Applies To: **1999-03 3.2 TL – ALL**
2001-03 3.2 CL – ALL

April 27, 2006

Blower Motor Does Not Work

(Supersedes 06-006, dated February 14, 2006 to update the information with the black bars)

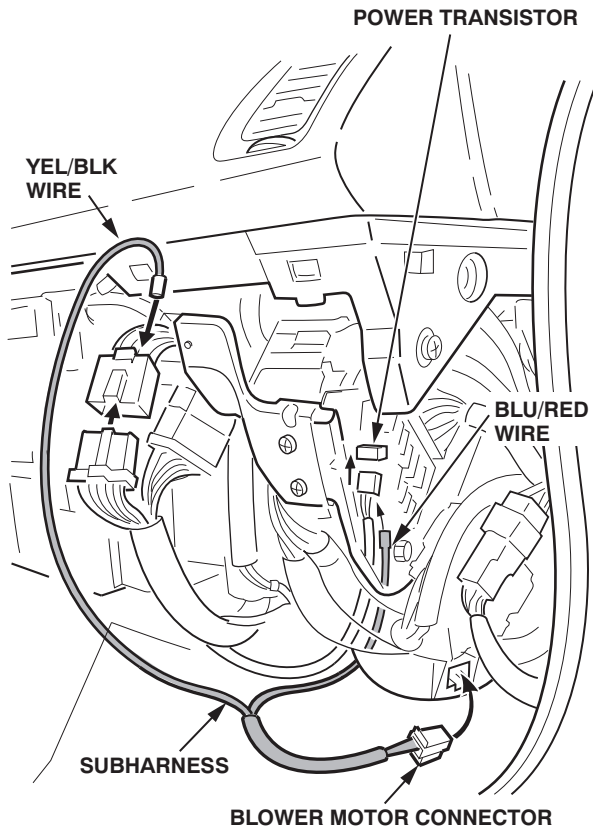
2. Disconnect the brown 7P connector (C202) from the main harness. Remove the YEL/BLK wire terminal from cavity 3 of connector C202. Cut off the terminal, and tape the remaining end of the wire to the harness.

3. Disconnect the 2P blower motor connector, cut off the connector, and tape the remaining ends of the wires to the pigtail. Then tape the pigtail to the main harness.
4. Disconnect the white 5P connector from the power transistor. Remove the BLU/RED wire terminal from cavity 4 of the power transistor connector. Cut off the terminal, and tape the remaining end of the wire to the harness.
5. Take the subharness, and insert the YEL/BLK wire terminal into cavity 3 of connector C202 and insert the BLU/RED wire terminal into cavity 4 of the power transistor connector. Tape both wires to the existing harness. Route the harness so there is no tension on the blower motor connector.

6. Reconnect connector C202 and the power transistor connector, then connect the 2P connector on the new subharness to the blower motor.
7. Verify the blower motor operates properly at all speeds.
8. Reinstall the glove box and cover.
